**DOCKET ITEM #10****Development Special Use Permit #2019-0003****TMP Special Use Permit #2019-0025****Special Use Permit #2019-0026****Monday Properties – 2000 N. Beauregard Street**

Purpose of Application
The applicant requests an amendment to DSUP #2017-0019 to request approval of a Development Special Use Permit (DSUP #2019-0003) with subdivision, site plan and modifications, and associated Special Use Permits, including a coordinated sign program and a Tier 2 TMP, in order to construct a multi-family building with 300 units, sitewide landscaping and pedestrian improvements and new vehicular infrastructure.
Special Use Permits and Modifications Requested:
<ol style="list-style-type: none">1. A development special use permit, subdivision and site plan with modifications to construct a multi-family residential building.2. A special use permit for a transportation management plan for Tier 2 (multi-family building); and3. A special use permit for a coordinated sign program.

Staff Recommendation: APPROVAL WITH CONDITIONS
Staff Reviewers: Robert M. Kerns, AICP, Division Chief, Robert.Kerns@alexandriava.gov Maya Contreras, Principal Planner, Maya.Contreras@alexandriava.gov Sara Bran

Figure 3: Comparison of approved site plan (DSUP #2017-0019) to requested amended site plan (DSUP #2019-0003).

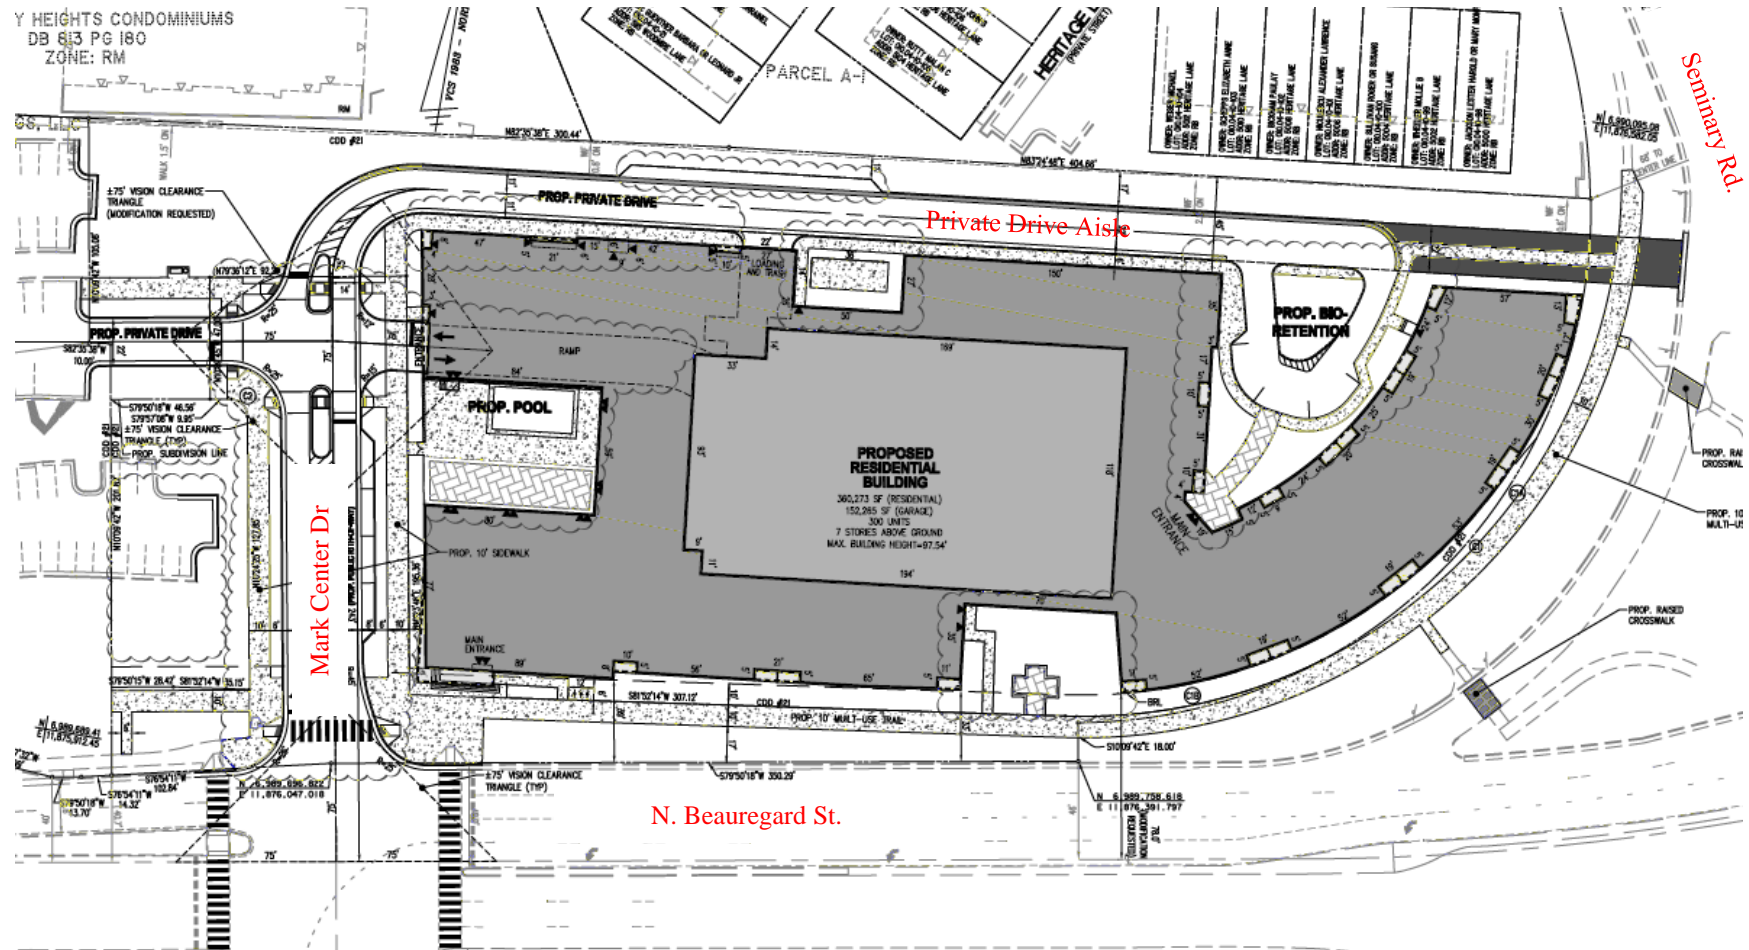
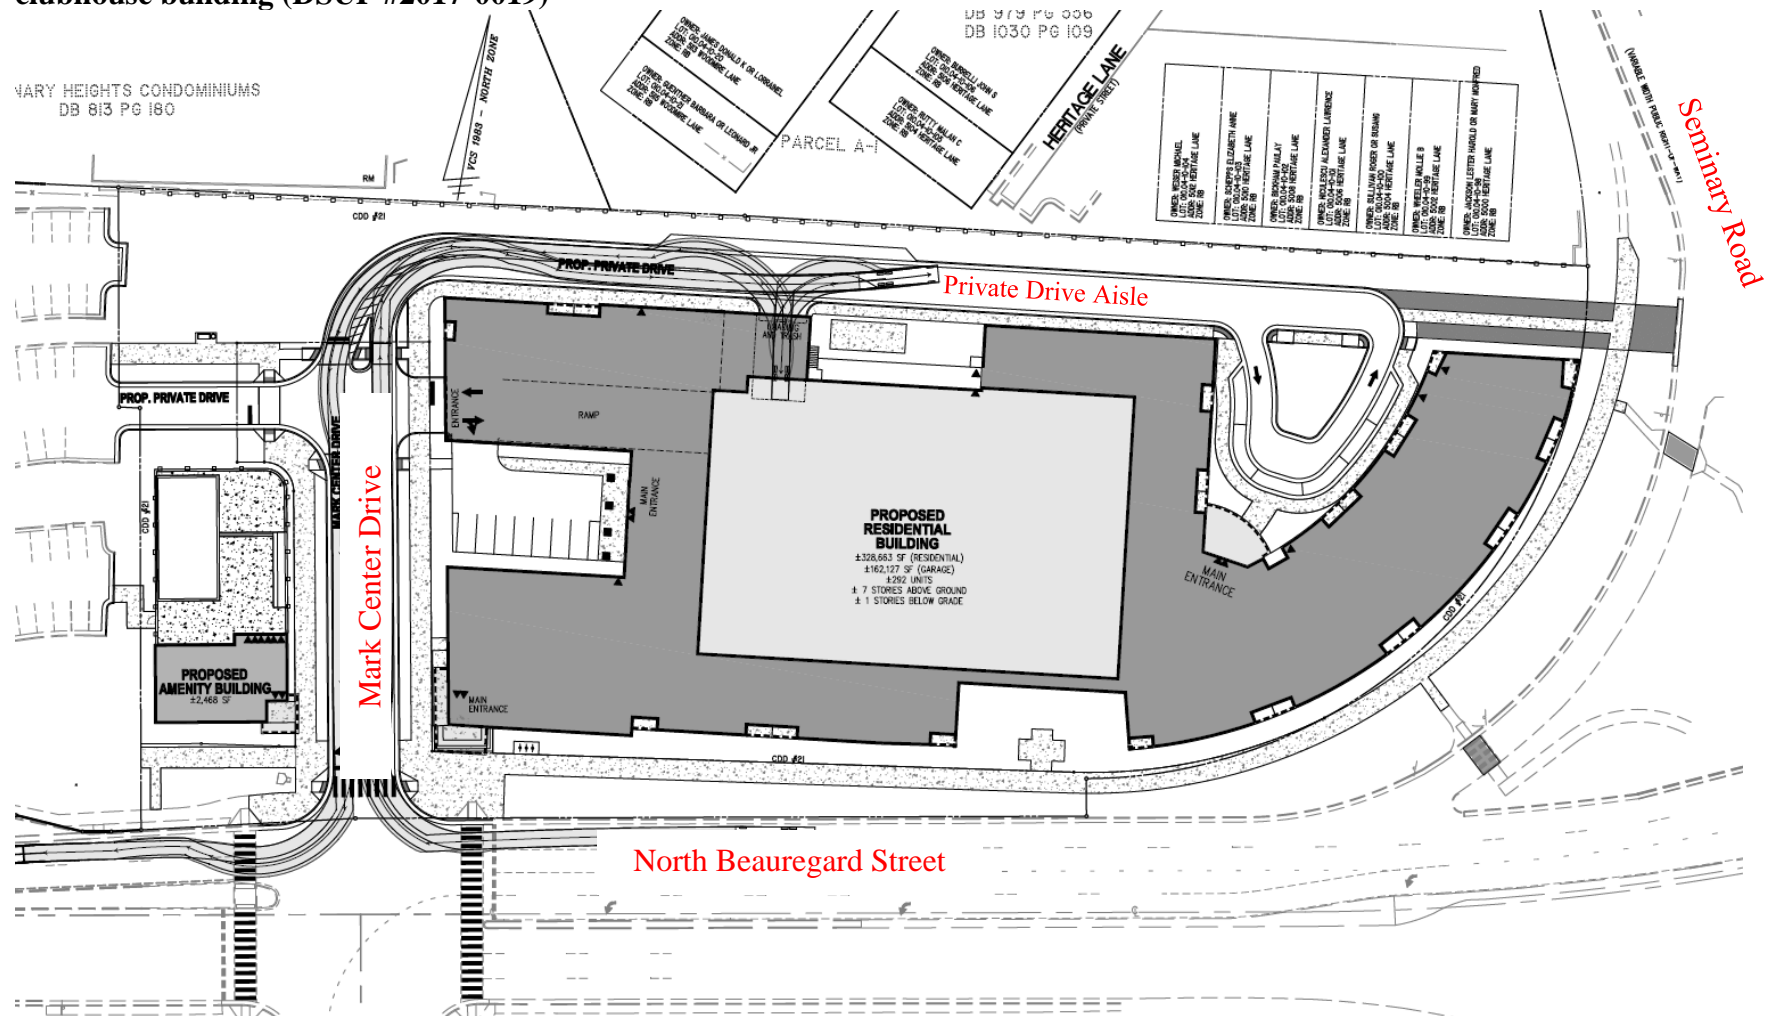
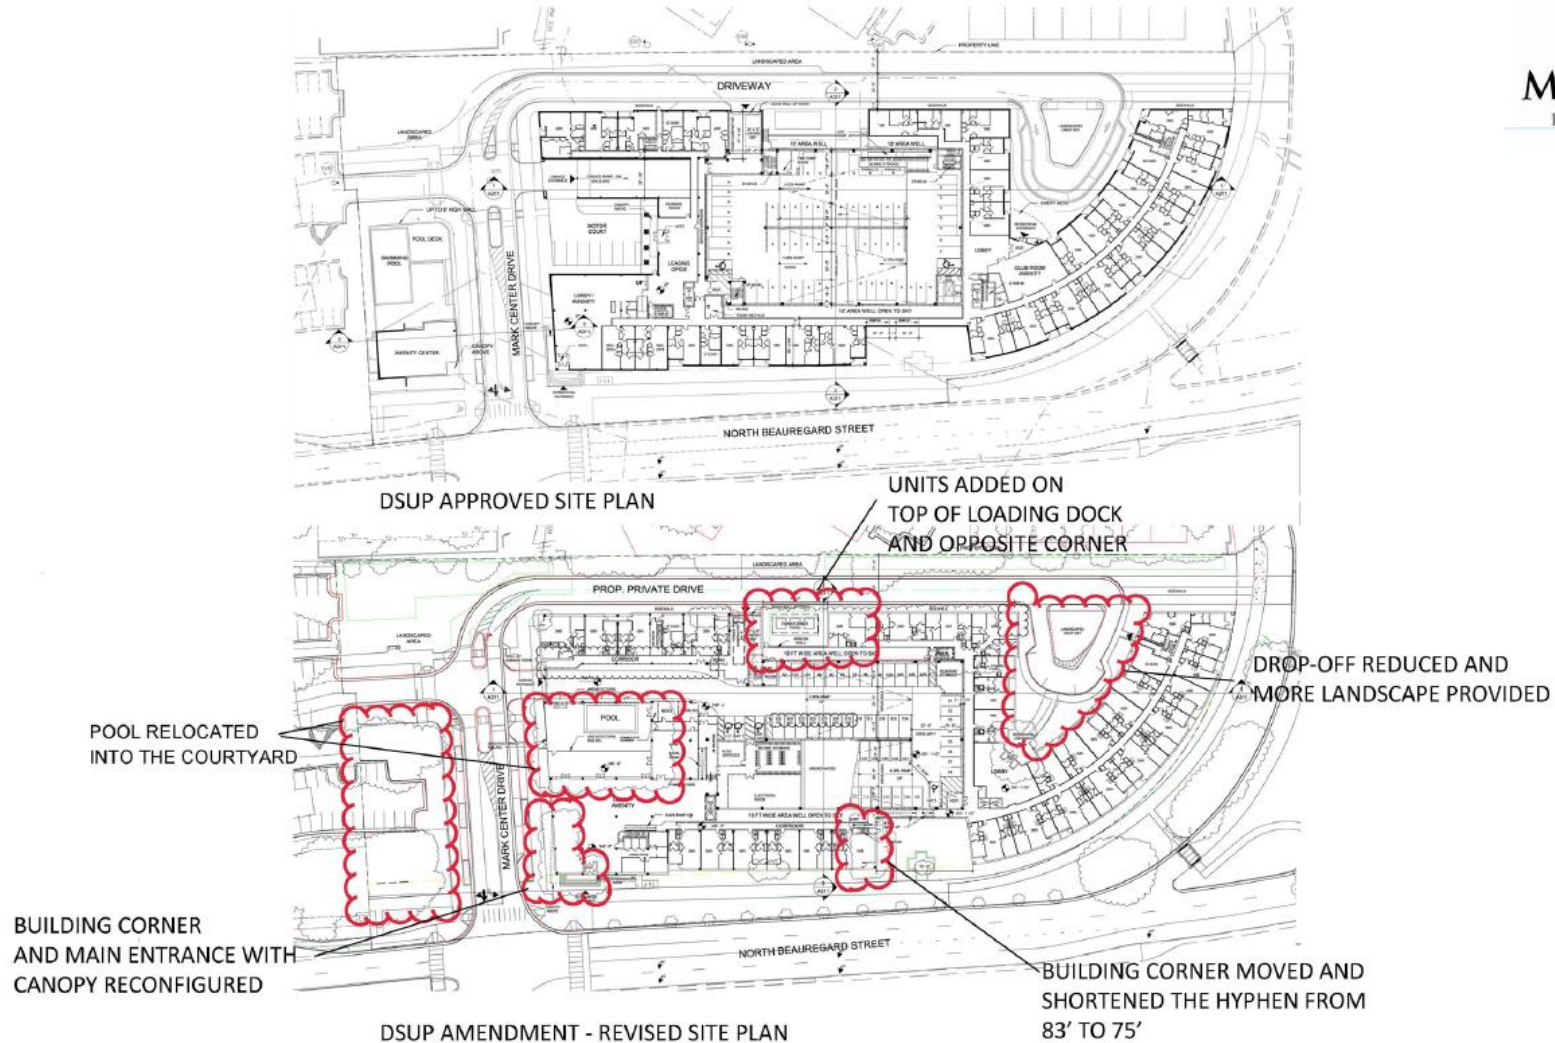
The applicant requested a site plan amendment to remove the clubhouse building and relocate the associated pool from a location across Mark Center Drive, to the central courtyard facing Mark Center Drive. By relocating the pool and moving the associated clubhouse functions into the building lobby, the applicant team has transformed the courtyard from a short-term parking area, into a consolidated amenity space for building residents.

To support the change in the pool location and to accommodate a change in short-term and visitor parking, staff requested changes to Mark Center Drive to maintain the existing pedestrian experience and stormwater infrastructure, and add four on-street, short-term parking spaces. As the applicant enhanced the functionality of Mark Center Drive to accommodate the change in parking, staff supports the removal of the clubhouse building. The relocated pool and clubhouse functions increases the usability of the amenity space as it will be more conveniently located for building residents. Furthermore, by proposing to screen the pool with a five-story building, instead of the previously proposed six-foot wall, the design is better able to reduce potential pool-related noises from disturbing the adjacent residential townhome community to the North.
